**RE: S38 Road Traffic Act 1994,  
Fiddown Village Improvement Scheme 2023**

**DATE: 11<sup>th</sup> October 2023**

### **FIDDOWN VILLAGE IMPROVEMENTS WORKS 2023**

Drawing Title: **Proposed Layout - (Sheet 1 of 2)**

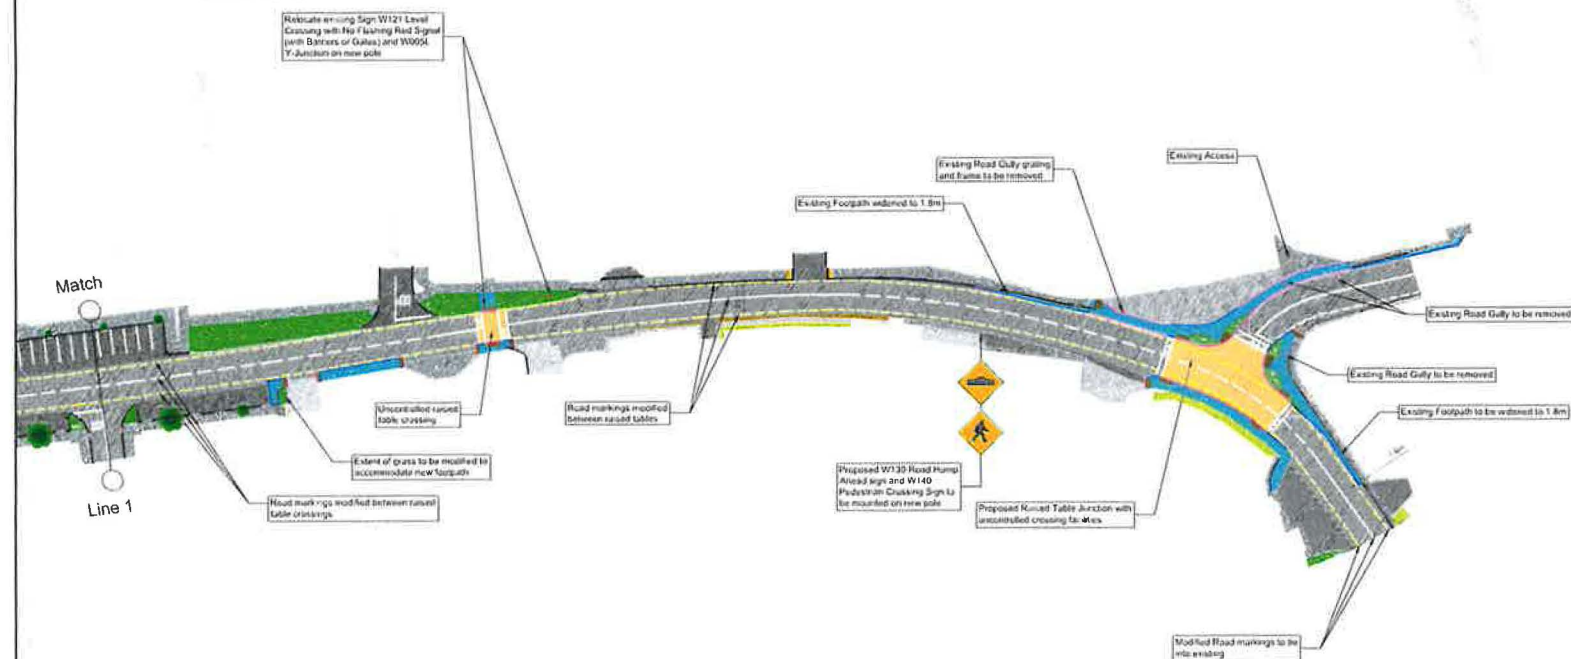
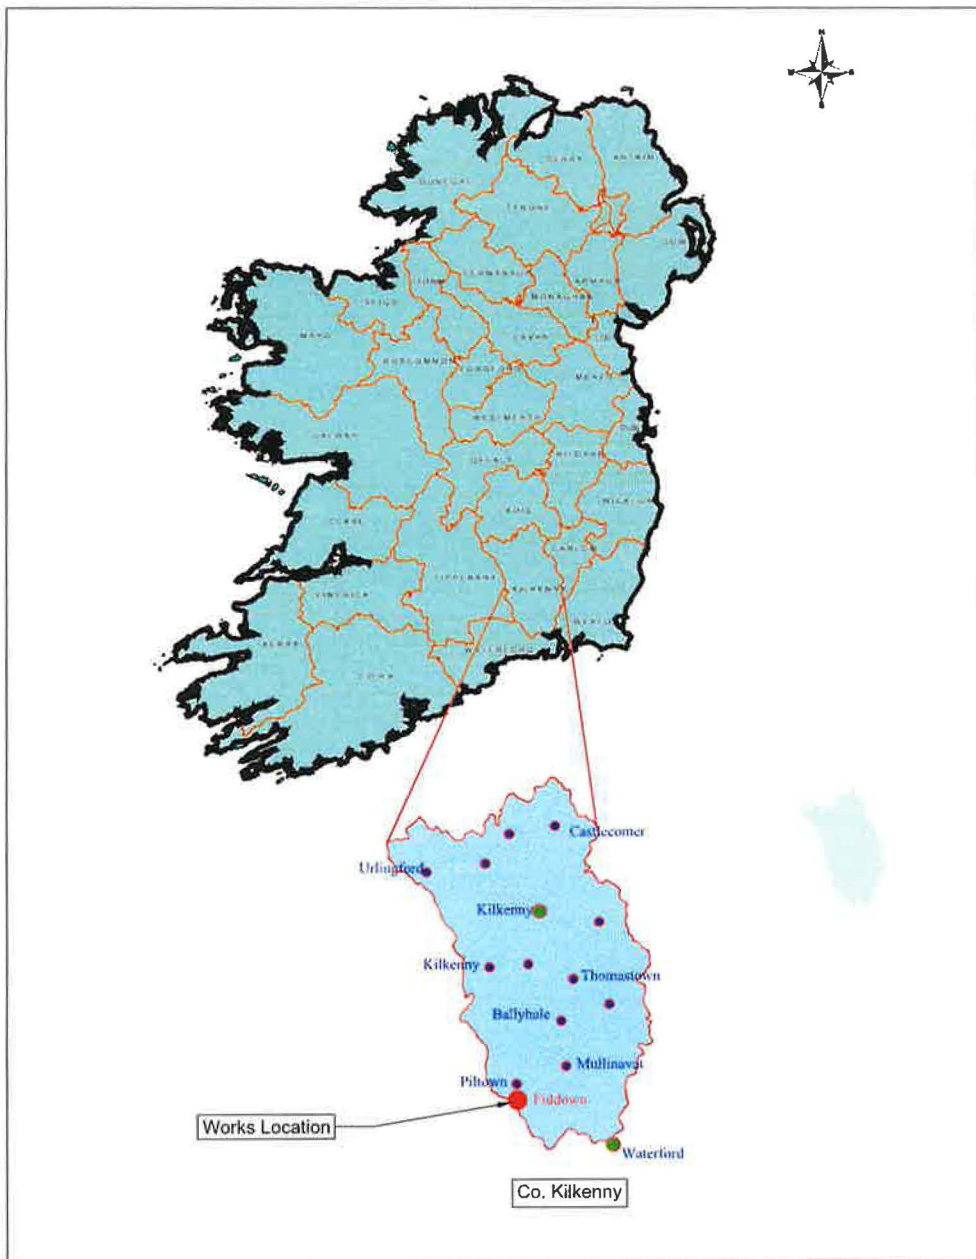
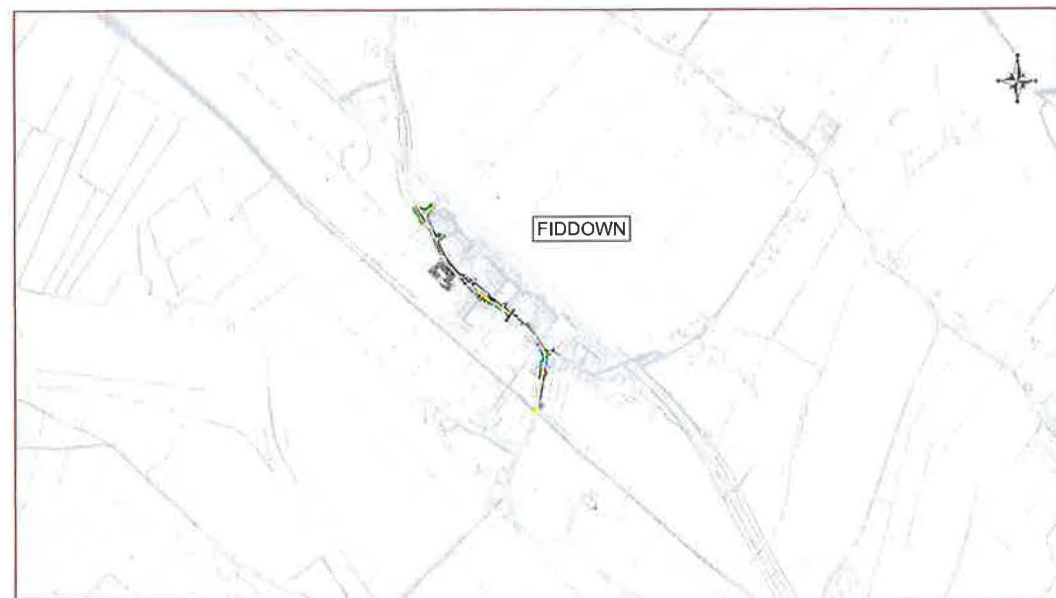
Concern regarding the bus stop location opposite Merry's garage regarding forward visibility for traffic approaching from Piltown and proximity to traffic movements at Merry's Garage.

Seeking clarification relating to construction of footpath in the vicinity of Meade's Pub and any connection between the footpaths and the existing pub structure.

Concern raised relating to impact of proposed scheme on building structure where the footpath is connected or where road levels are raised in front of the building

I refer to Draft 2 proposed Layout (sheet 2 of 2) of the above proposed works for Fiddown, Co. Kilkenny and request further information in relation to the proposed footpath to be laid outside my business premises and my home, The Toll Bridge Tavern, more commonly known as Meade's.

As Stan Cullen is aware, the level of the existing road has already impacted negatively on my premises and I would like confirmation if the proposed footpath will be buttressed directly against my property, which is roadside. If this is the case, then I object, in principle, to the footpath being laid outside my premises, as another layer of tarmac/concrete would exacerbate an already existing problem.

The proposed bus stops are intended to include bus shelters and kassel kerbing and are to be connected to key destinations in the village by accessible footpaths and road crossings.

Sight lines to and from the proposed bus stop locations meet the requirements of the applicable design standards.

In addition, the provision of pedestrian crossings with raised tables at regular intervals through the village will serve to calm traffic and shall ensure speeds on approach to the bus stopping locations are appropriate.

The proposed arrangement in the vicinity of Meade's Pub will not involve any buttressing against the building structure at that location and the pavement immediately in front of the property will not be modified.

Footpaths will be provided as part of the junction tightening with level differences limited in places to facilitate short duration vehicular access to the property as well as access for pedestrians at crossing locations.

New gullies will be provided at low points in the area where existing surface water flow lines are modified by the introduction of footpaths.

In addition, where paving is to be modified, a channel will be formed between the paving and the building at the edge of the paving to collect runoff from the pavement and footpath where necessary. This channel will outfall into gullies which will connect with the closed drainage network.
